Chiller Replacement Project – St. Augustine Campus (BID-SJR-13-2023)

ADDENDUM No. 1

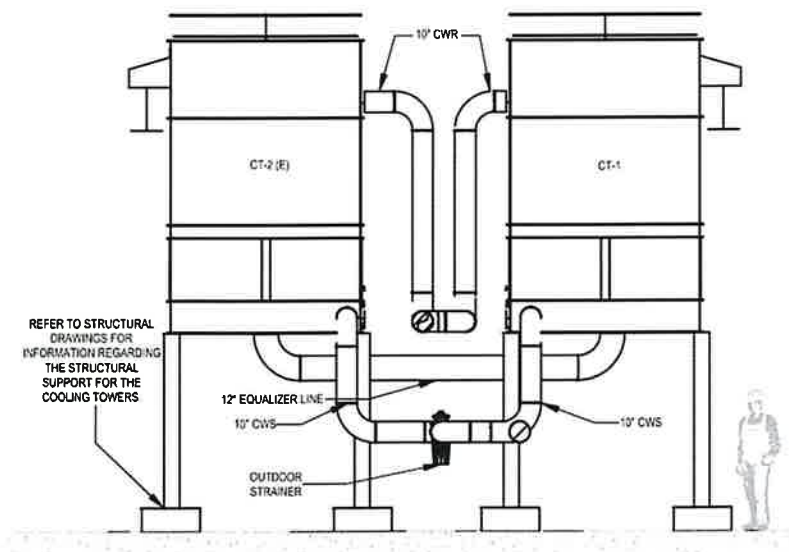
Question #14: The new cooling tower seems to overlap a little on the driveway into the CEP. We may need to add notes to the drawings to cover scope to modify.

Answer #14: We will add keynotes as part of Addendum No. 1 to cover this expansion.

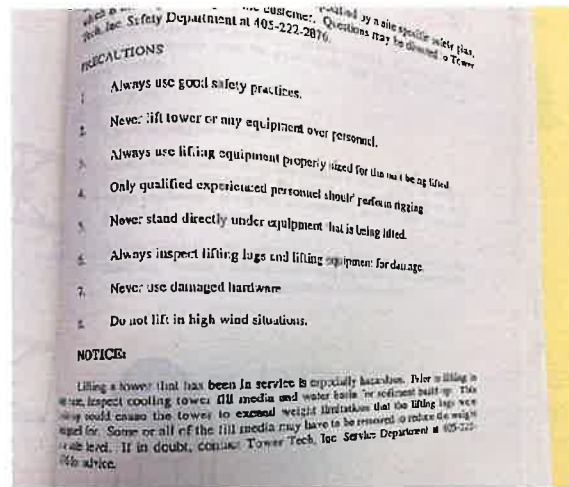
Question #15: The existing tower does not appear to have an equalizer pipe connection, or it was piped incorrectly (see photo below).

Question #16: Add a note to the chemical treatment that the provider is to be Nalco.

Answer #15: Confirmed the existing tower is piped incorrectly to support a second cooling tower. We will need to re-pipe in order to correct. Unfortunately, this will mean that the existing chiller will have some down time. This should be minimal if as much pipe is preinstalled and the final connections coordinated with college's schedule to avoid affecting the campus.

Answer #16: Note will be added under Addendum No. 1. Drawing change required.
